Office Action Summary

10/779,632

DETAILED ACTION

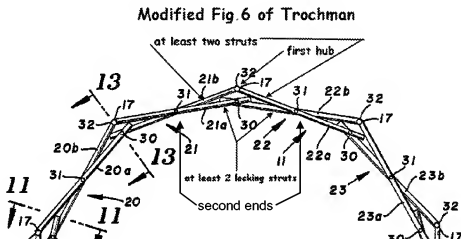
20. In Re claim 1, Figure 4 and 6 of Trochman teach a first hub (32); at least two struts (21b, 22a from Fig. 6 above) pivotably connected at first ends thereof to the first hub (32) and movable relative to each other between a folded position and an expanded position;

at least two locking struts (see Fig. 6 above) pivotably connected at first ends thereof (30) to a hub, and at second ends therefore, to connection points (see Fig. 6 above) on respective ones of the at least two struts.

The Examiner notes that the "second ends" is being interpreted to be the connection points as shown above in Modified Figure 6. It is recognized that the second ends as interpreted above is not that of the present invention, however, the language of the claim does not incorporate limitations the specifically limit the scope of the claims to be only the distal end of the locking strut.

31. In Re claim 12, Figure 6 of Trochman (see modified figure 6 above) discloses at least two second struts (20a , 23b) pivotably connected at first ends thereof to respective ones of the at least two struts,

at least two second hubs (30 – top left and right), second ends of the at least two second struts being pivotably connected to respective ones of the at least two second hubs,

at least two third struts (24c, 25c), first ends of the at least two third struts being pivotably connected to respective ones of the at least two second hubs,

at least two third hubs (32 - bottom left and right), second ends of the at least two first struts being pivotably connected to respective ones of the at least two third hubs,

at least two fourth struts (24a, 25b), first ends of the at least two fourth struts being pivotably connected to respective ones of the at least two third hubs and being pivotably connected to respective ones of the at least two third struts.
